## DEVELOPMENT APPLICATION ASSESSMENT REPORT

<b>Application Number:</b>	DA2019/0154
----------------------------	-------------

<b>Responsible Officer:</b>	Catriona Shirley
<b>Land to be developed (Address):</b>	Lot 1 DP 373531, 1955 Pittwater Road BAYVIEW NSW 2104
<b>Proposed Development:</b>	Demolition works and construction of a seniors housing development
<b>Zoning:</b>	R2 Low Density Residential
<b>Development Permissible:</b>	Yes, under SEPP (Housing for Seniors or People with a Disability) 2004
<b>Existing Use Rights:</b>	No
<b>Consent Authority:</b>	Northern Beaches Council
<b>Delegation Level:</b>	NBLPP
<b>Land and Environment Court Action:</b>	Yes
<b>Owner:</b>	Ian Francis Westaway Jan Elizabeth Westaway J A Westaway & Son Pty Ltd
<b>Applicant:</b>	Ian Francis Westaway Jan Elizabeth Westaway Vaughan Milligan Development Consulting Pty Ltd

**Figure 1.** Shadow over the rear windows  
**Figure 3.** Shadow still over rear windows  
and Court Yard of Unit 1 at 9.00am  
and Court Yard at 3.00pm

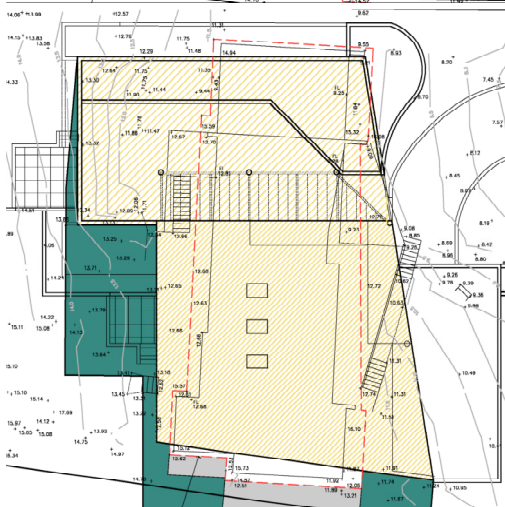
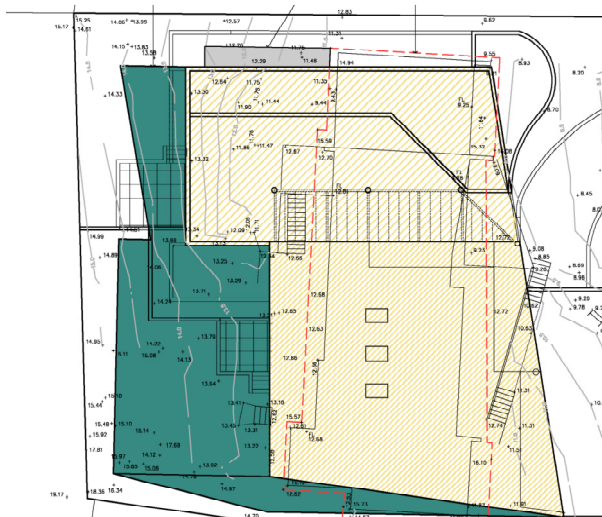
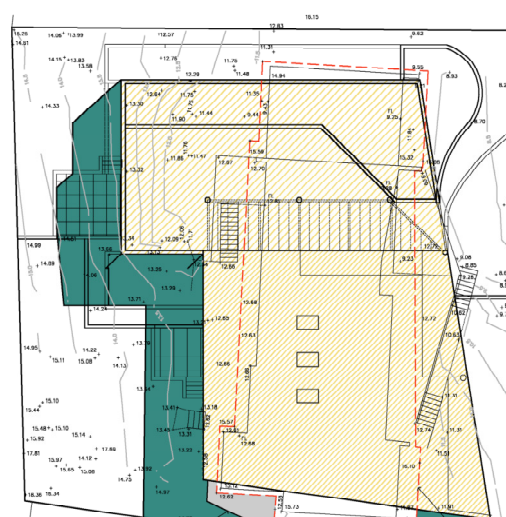
The shadow diagrams below show that the rear windows (adjoining living rooms) and courtyard of Unit 1 are in shadow between 9am and 3pm.

**Photo 4.** Existing Pittwater Road presentation (amended scheme).  
of a "detached style" dwelling house.

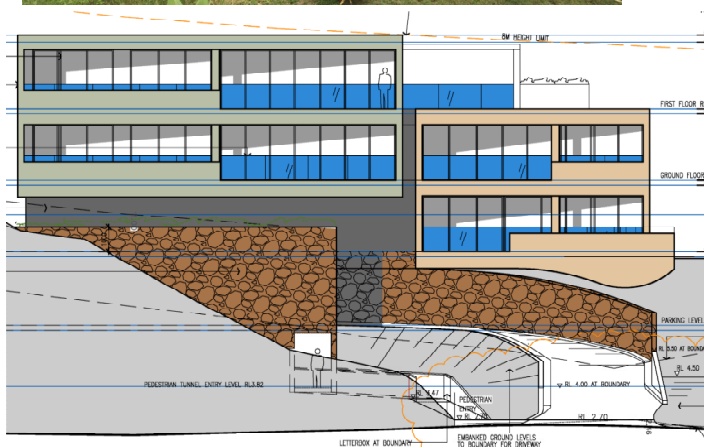
The proposed development is of a greater scale than any other development within the visual catchment of the site. The development also exceeds the built form controls prescribed by Pittwater 21 DCP and the built form development standards within the PLEP and SEPP HSPD. Overall, it cannot be said that the bulk and scale of the development is minimised in that the proposal exhibits excessive bulk, scale and mass that is not consistent with the built form of low-density "detached" style housing in the surrounding area as shown below.
